**International  
Aero Engines**

# **SERVICE BULLETIN**

NACELLE – HYDRAULIC POWER – LOW PRESSURE (LP) HYDRAULIC SWITCH –  
INSTALLATION OF ANCHOR TABS AND LOCKING WIRE

# **V2500-NAC-29-0262**

Installation of the Anchor Tabs and Locking Wire to the LP Hydraulic Switch  
Figure 1, Sheet 1 of 2

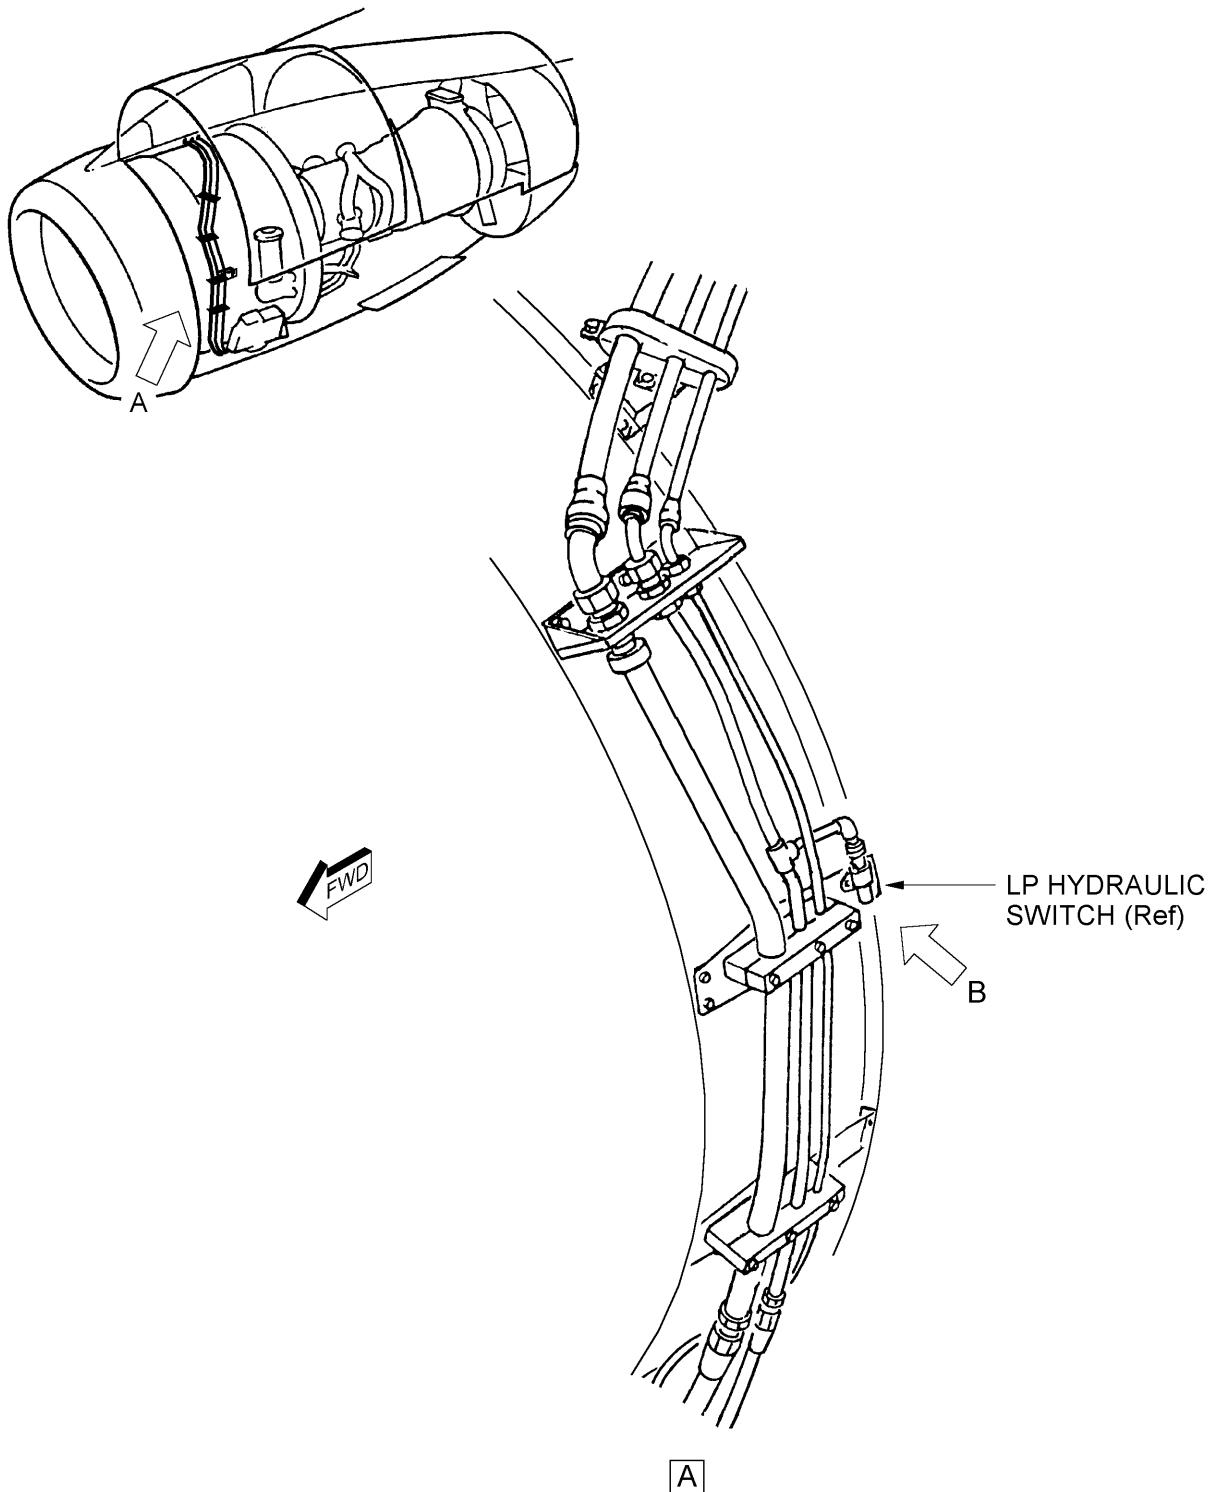
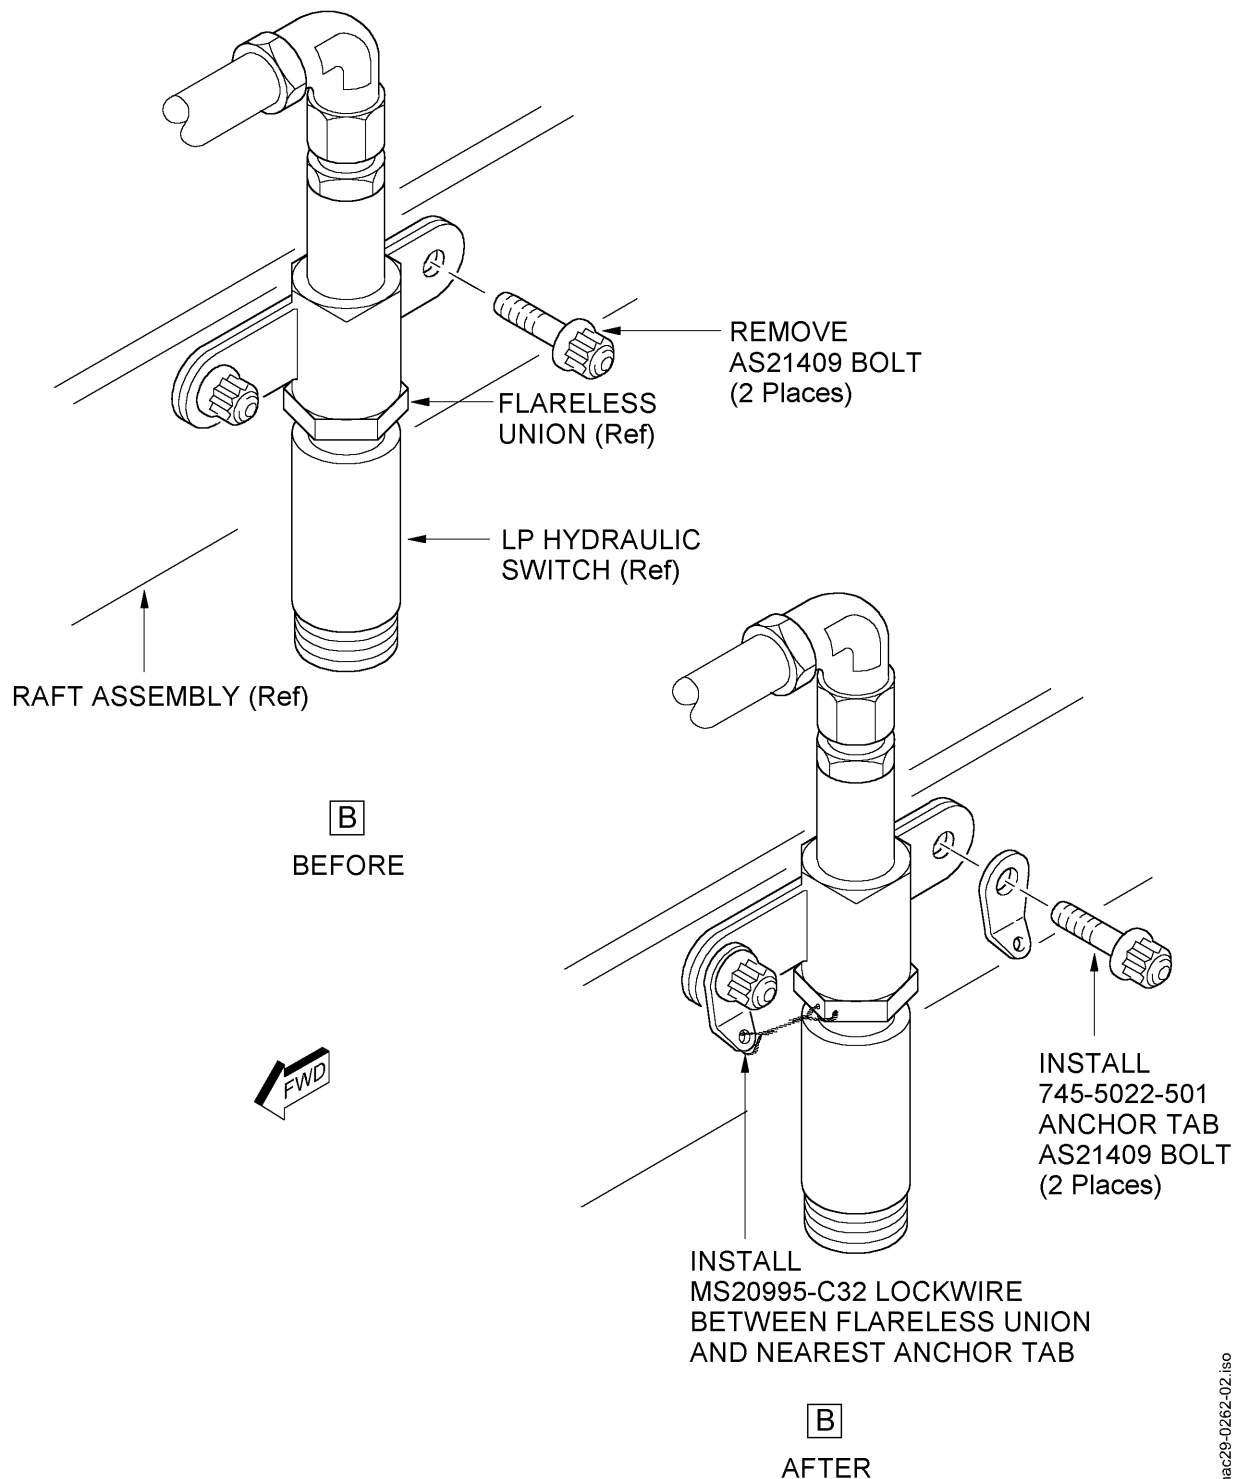
- Two Bolts that secure the LP Hydraulic Switch to the Raft Assembly are removed.
- The LP Hydraulic Switch is secured to the Raft Assembly with the two Bolts and two new Anchor Tabs.
- The Flareless Union of the LP Hydraulic Switch is wire locked to the nearest of the two Anchor Tabs.

- (1) Remove the two AS21409 Bolts from the Raft Assembly. Refer to Figure 1.

**NOTE:** There are two new Anchor Tabs installed to facilitate the use of Locking Wire. Safety the LP Hydraulic Switch to the nearest of the two Anchor Tabs only.

- (5) Safety the LP Hydraulic Switch Flareless Union to the 745-5022-501 Anchor Tab with CoMat 02-147 Locking Wire. Refer to the SPP-V2500-1IA Standard/Processes Manual, Chapter 70-42-05.
